SUBJECT: Class II Permissive change

FCC ID: MMALXT600PA

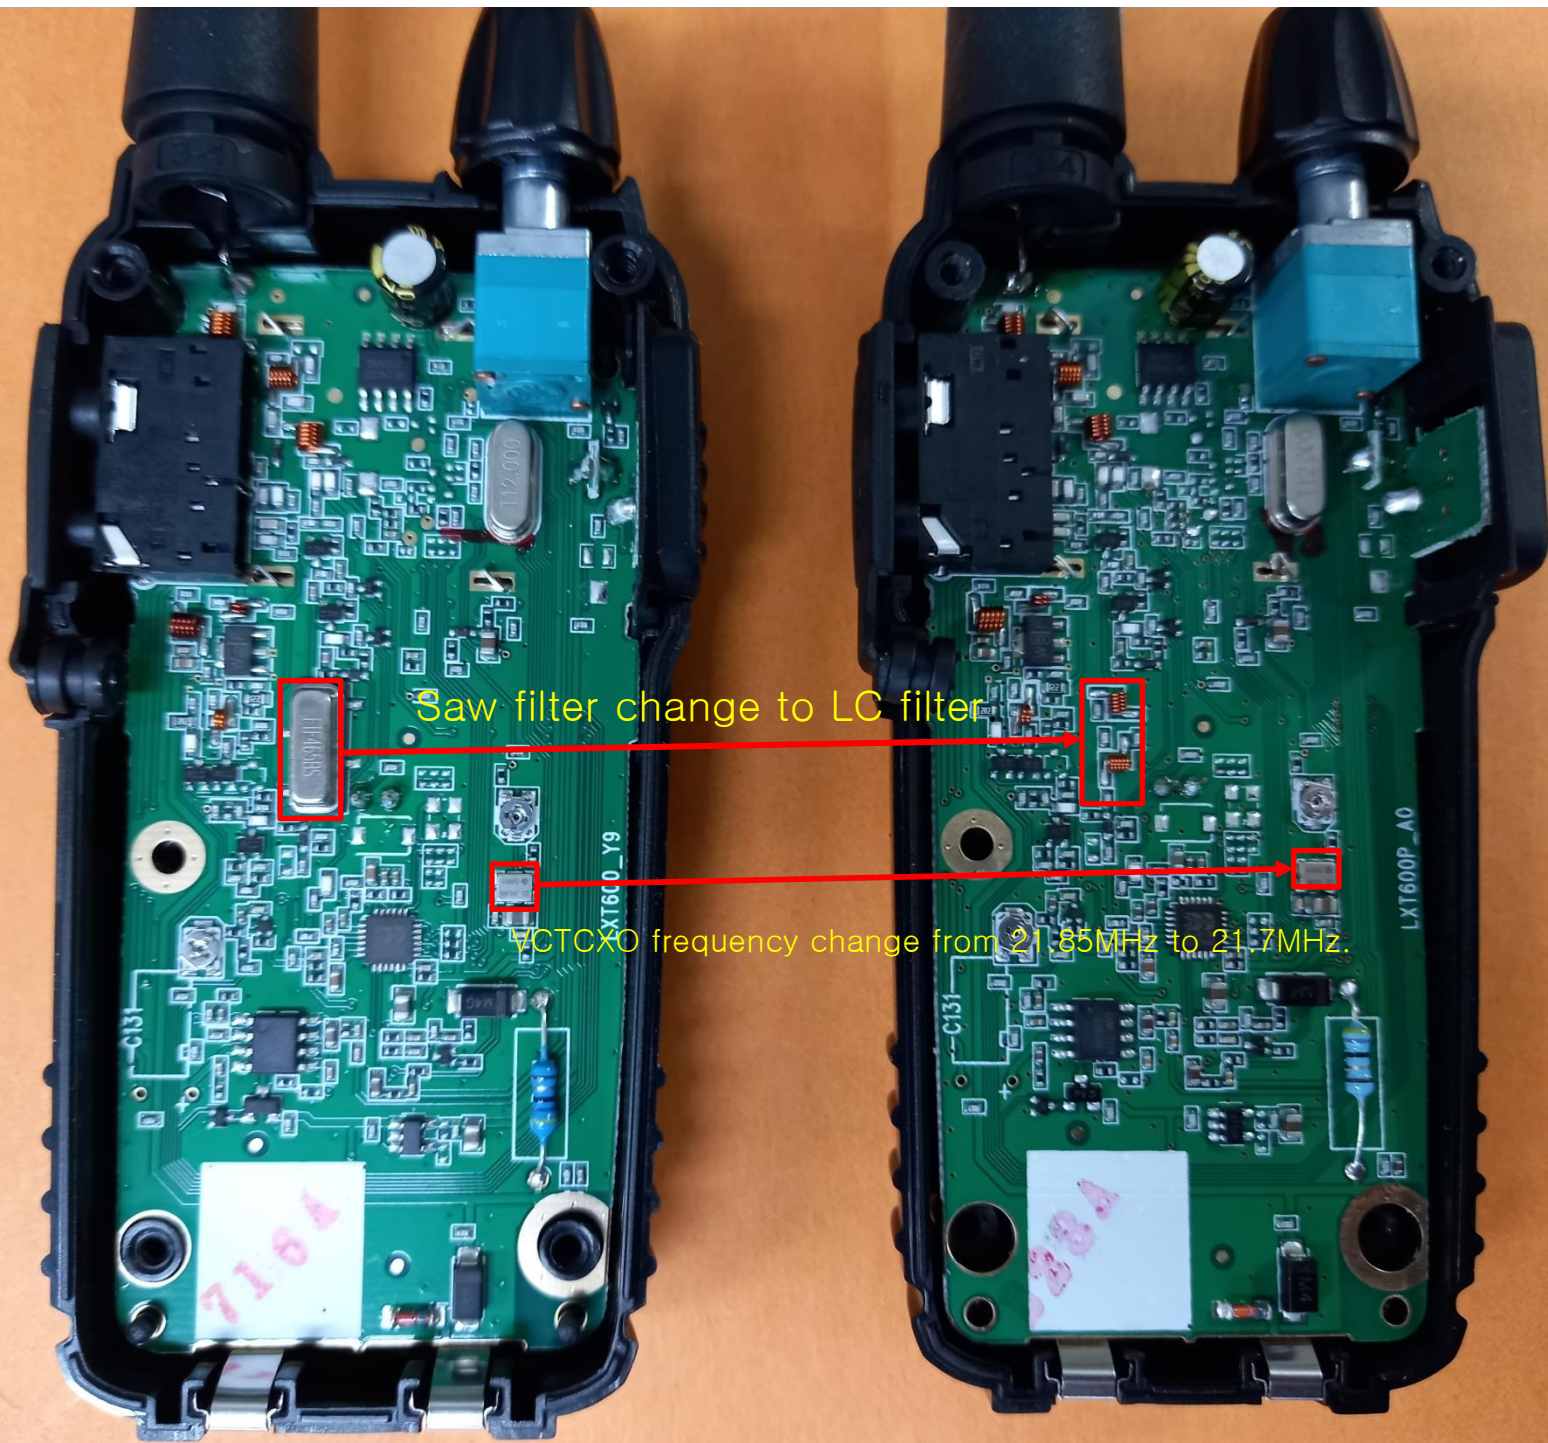
- 1) SF1(FTF465BS) of Saw filter change to Y12 LC filter(C69, C71, C72, C75, L16, L19)
- 2) TCXO1(21.85MHz) only change frequency to 21.7MHz.

Saw filter change to LC filter

VCTCXO frequency change from 21.85MHz to 21.7MHz.
